Alarm Light Main board / Juraj Repcik

Alight_main_board_v3

Sheet: 3/3

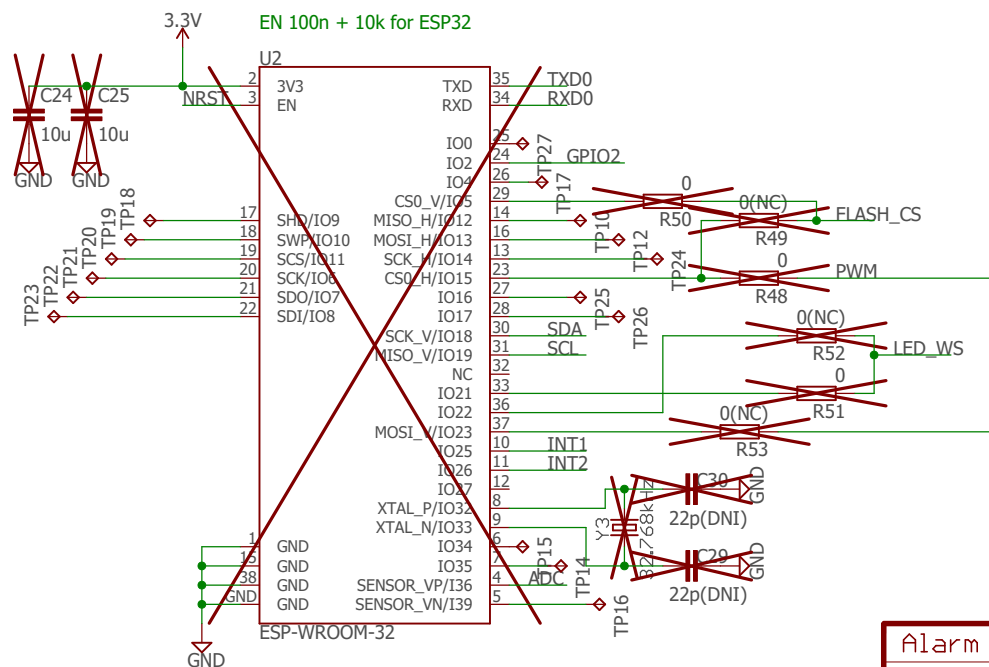
add divider to FB
resistors and parallell C
if LM3671-ADJ was used.
